(SP) No.11-023

14th July, 2011

IC FAB change updated schedule of Fujimi Build. #D closure

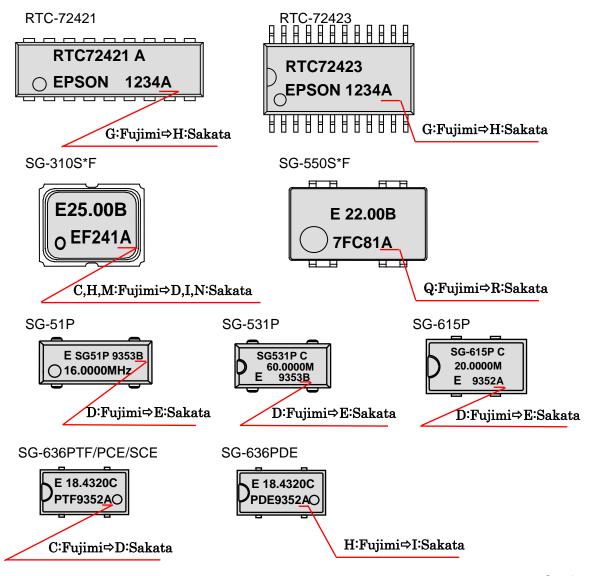
(1) Identification

Marking of version number will be changed as ID. New version number will be deferent by each product type as shown below.
